ADDENDUM NO. 01

RANKIN TRAILS AMPHITHEATER AND BASEBALL PARK

Rankin County, Mississippi

WBA Proj. # 2215/2315

C0.3
PROJECT BID
LIMITS

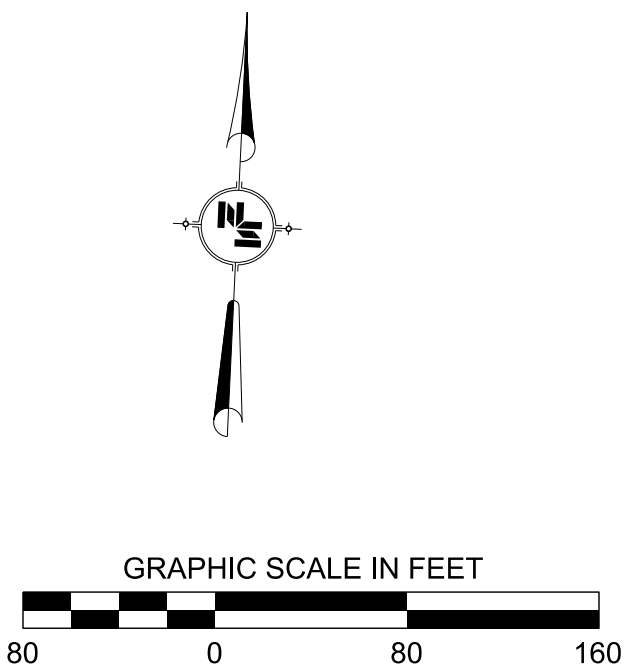
REVISE the numbering of the Alternate Bids #3 and #4, per enclosed revised sheet C0.3.

C1.0

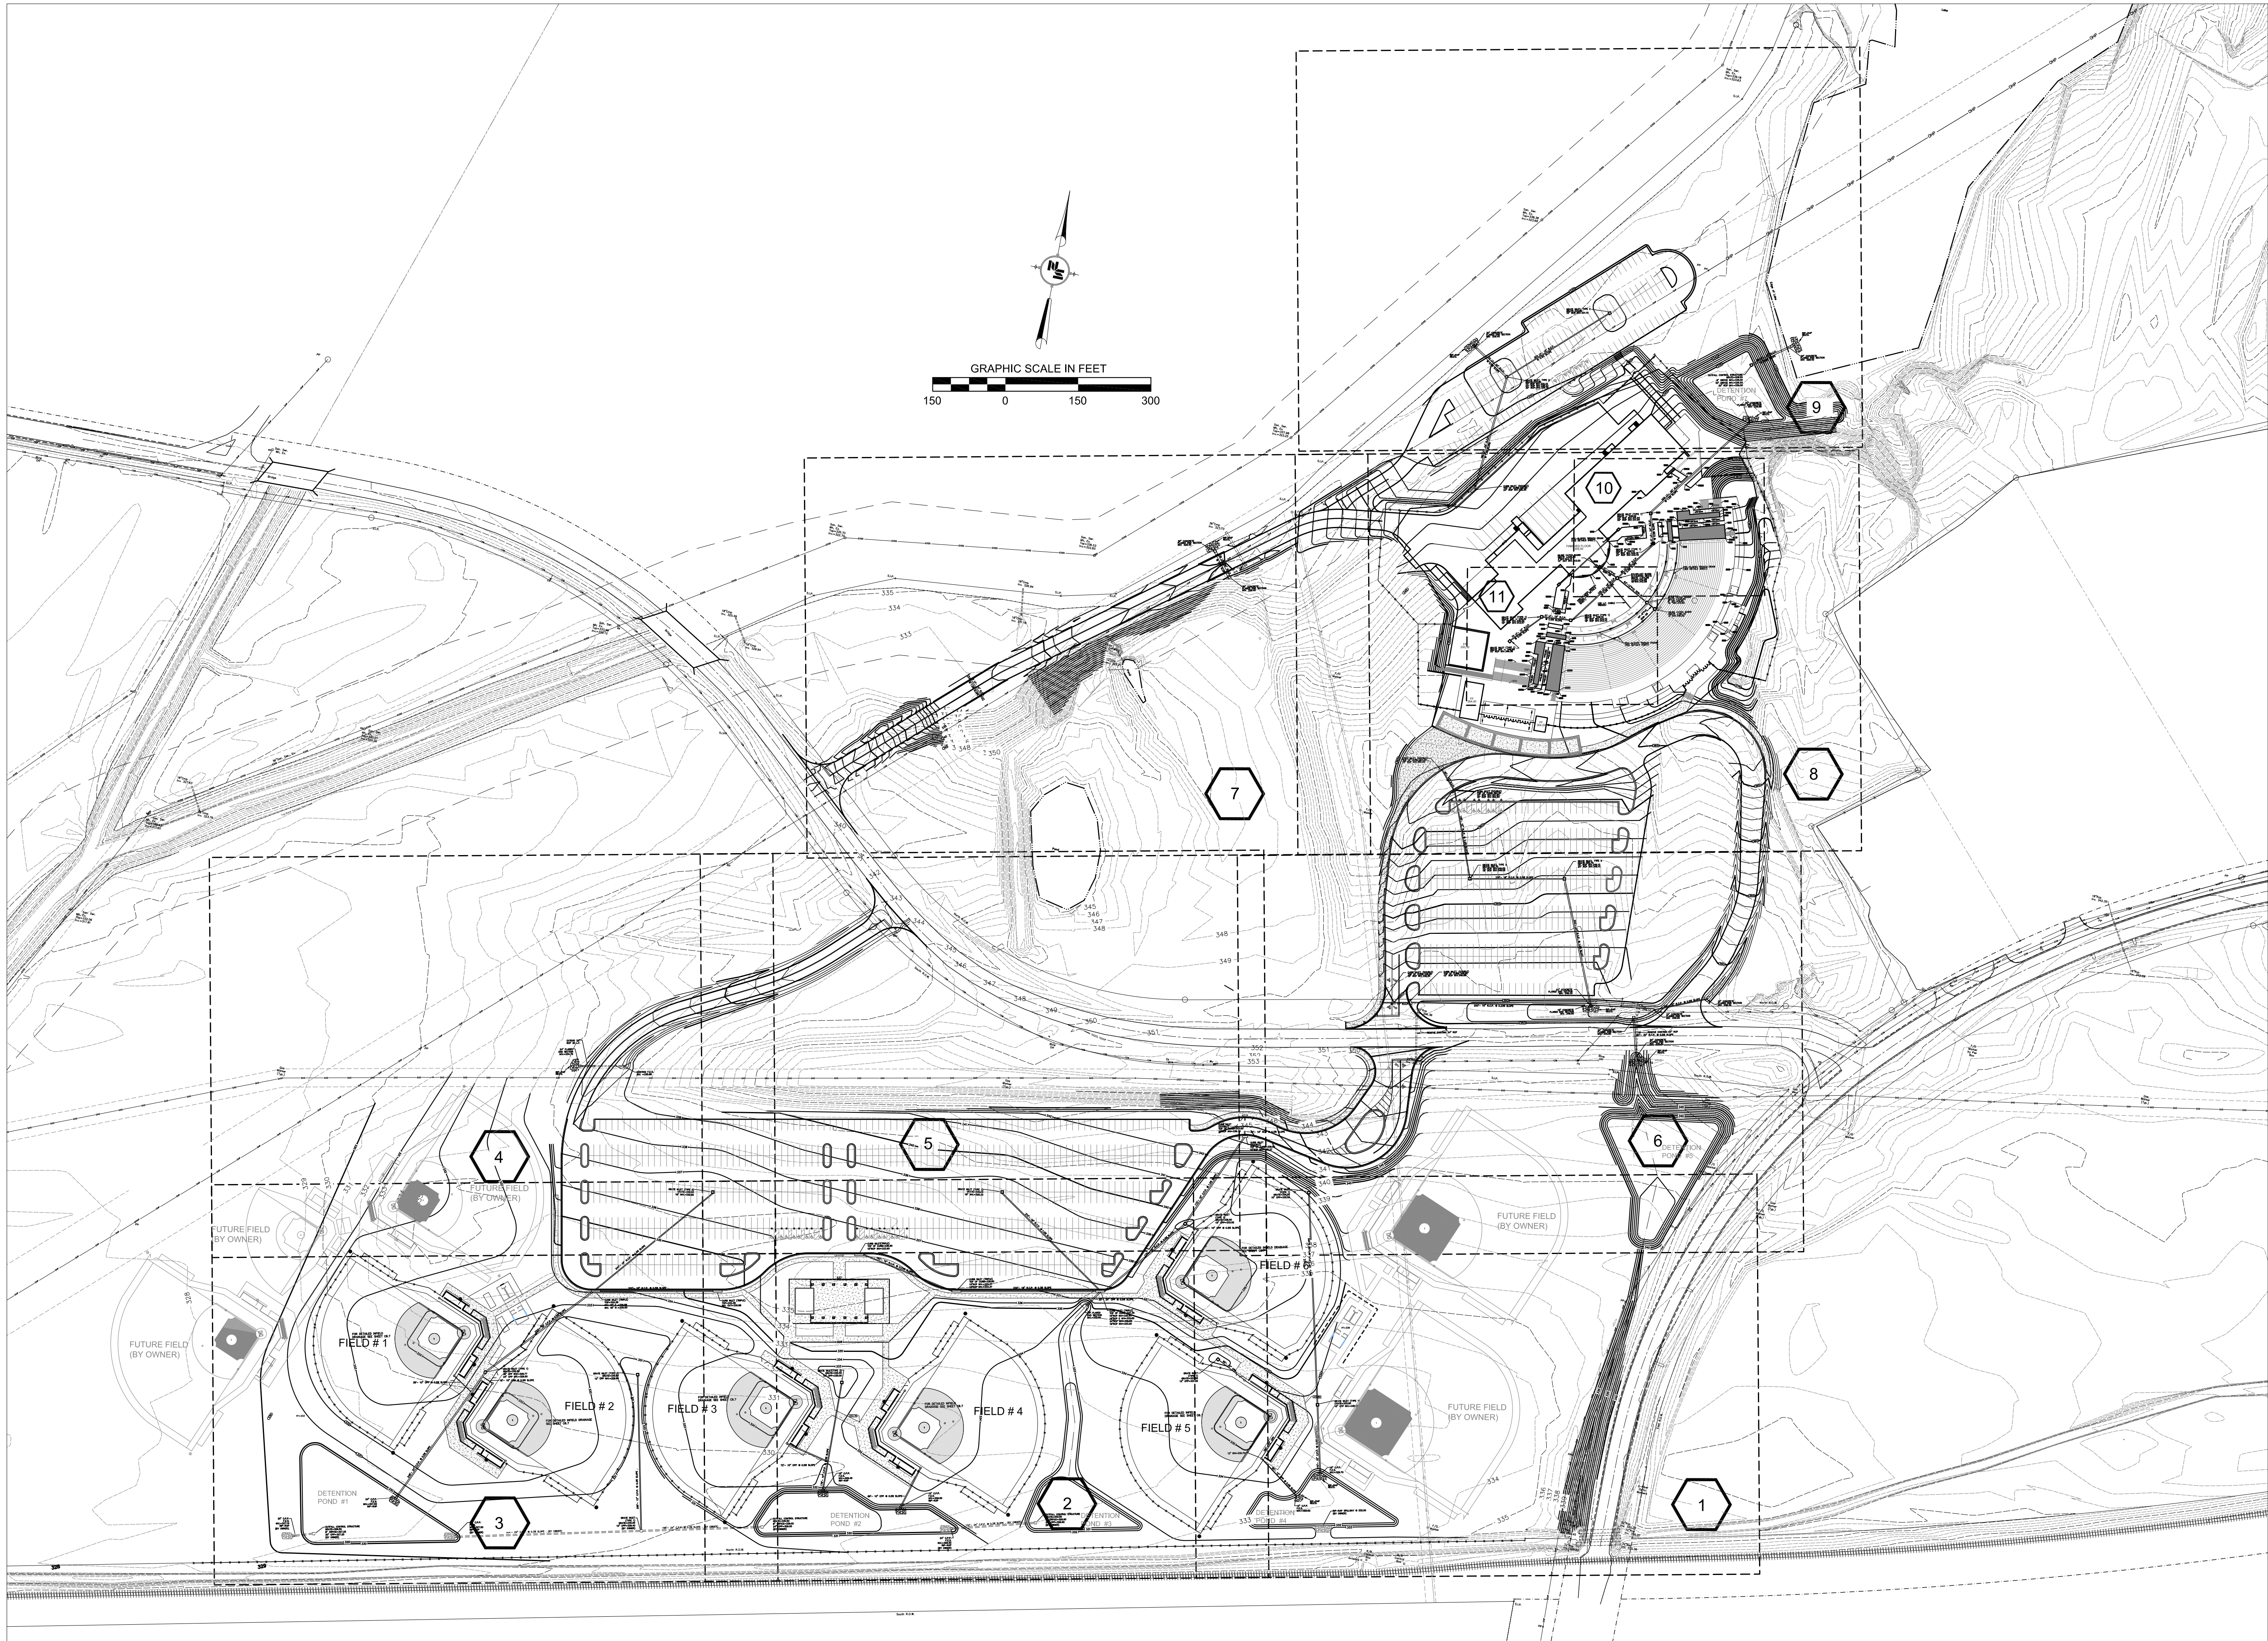
ADD location of sheet 11, per enclosed revised sheet C1.0.

C1.8

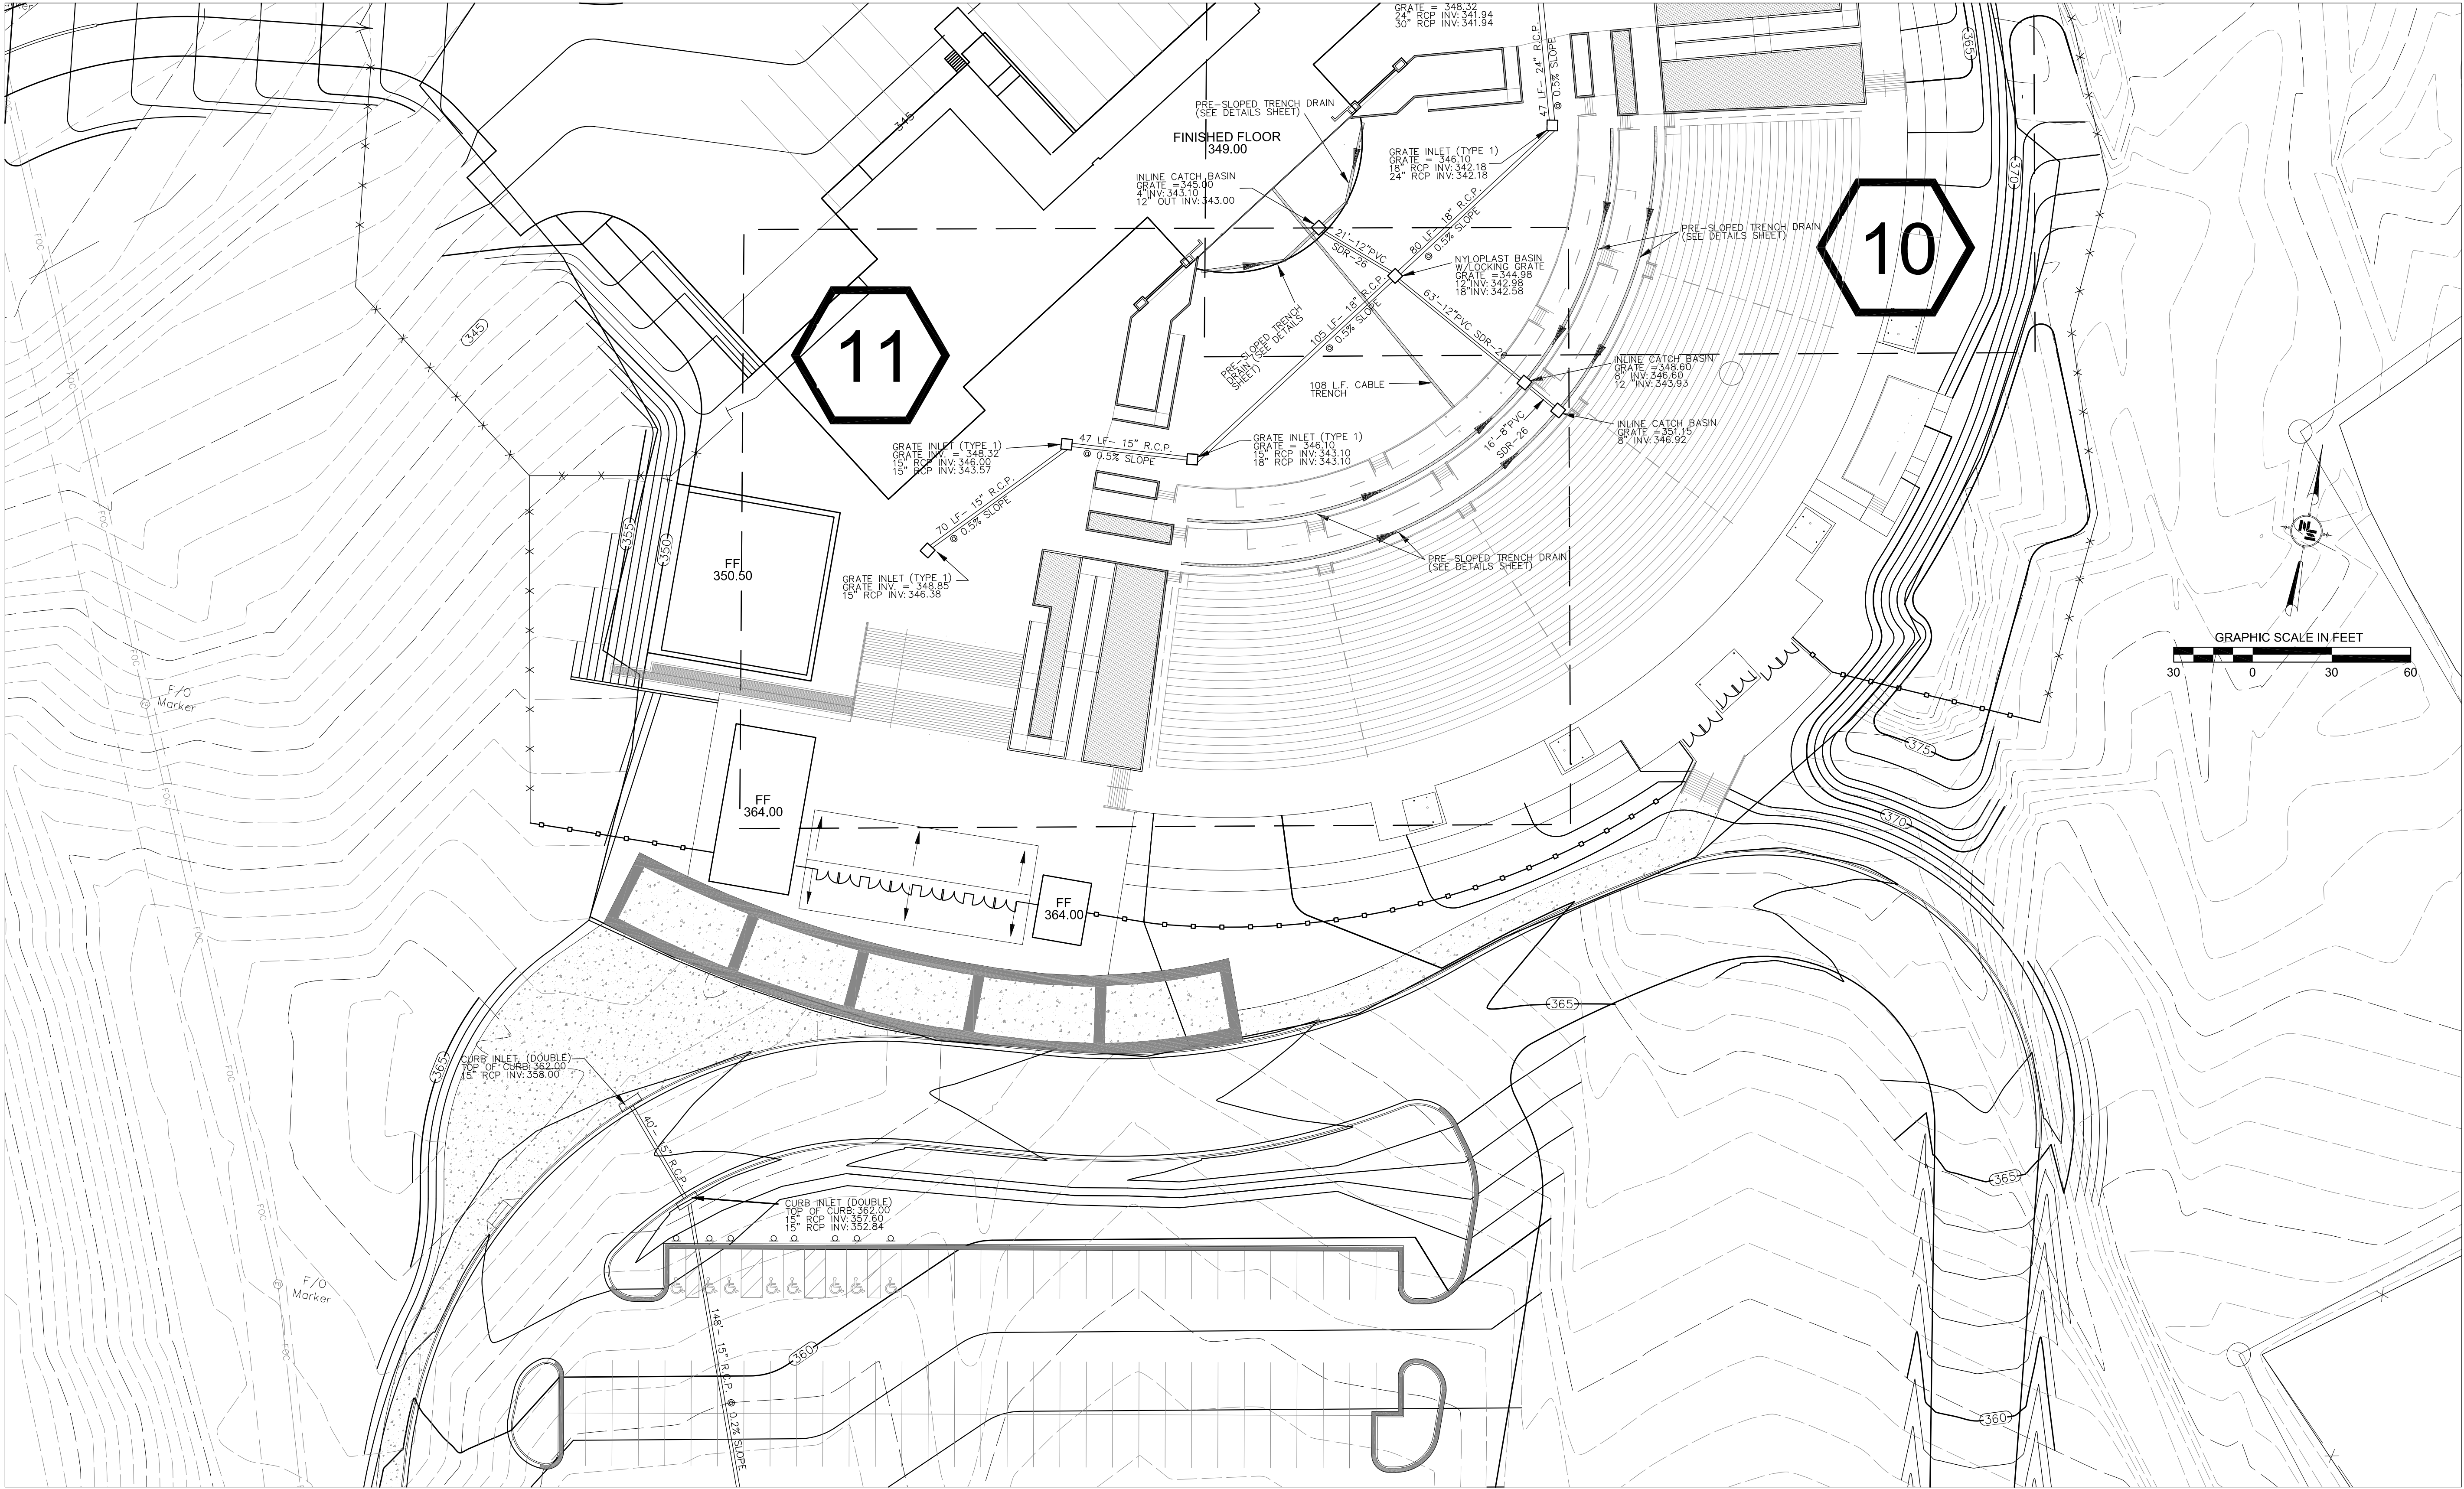
ADD location of sheet 11, per enclosed revised sheet C1.8.
